Technical News of EFP Related Products

Subject	Notification of Failure 3803 Group H Specification Parallel Input-Output Mode			
Product	EF3803F-64F,EF3803F-64H,EF3803F-64U,EF3803F-64S,EF3803F-64B	Number	A05H24-02	
Object Lot	All Lots	Date	Aug.24,2005	Rev. B

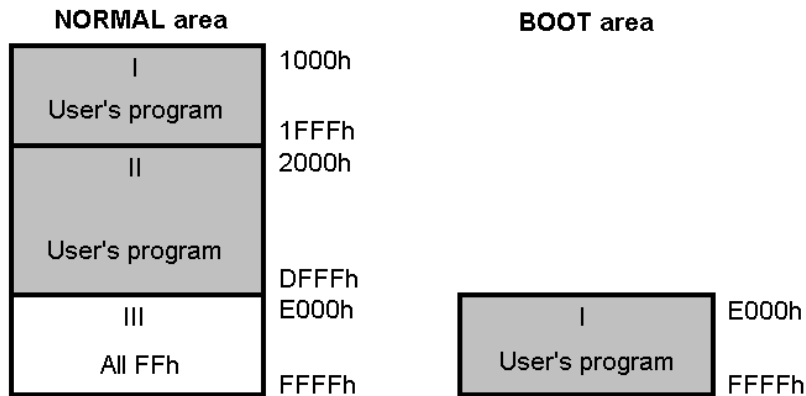
In parallel input-output mode of 3803 group H specification, if data rewritten of NORMAL area is conducted with the writer in the setting of M38xxxFFH(NORMAL), data of NORMAL area will be written in BOOT area.

After the writer is set as M38xxxFFH(NORMAL), in case a certain error occurs during executing "All Erase" command, Boot/Normal area select process on the side of WinEfpRE and WinEFP control software causes malfunction and the command is always executed on Boot area side.

Though the area of the writer is set to be BOOT area (E000h ~ FFFFh), the execution area of the command shows NORMAL area (1000h ~ FFFFh). The area (1000h ~ DFFFh) which does not overlap is used for Normal area, however, the area (E000h ~ FFFFh) which overlaps is used for Boot area. It causes this failure.

After the failure occurs, if rewritten of all NORMAL areas is executed with E.B.P.V. macro command, etc., the following areas marked with will be rewritten.

This error can be fixed by upgrading Writer control software WinEfpRE.

*Error correction version is WinEfpRE Ver.1.30.05 or above.
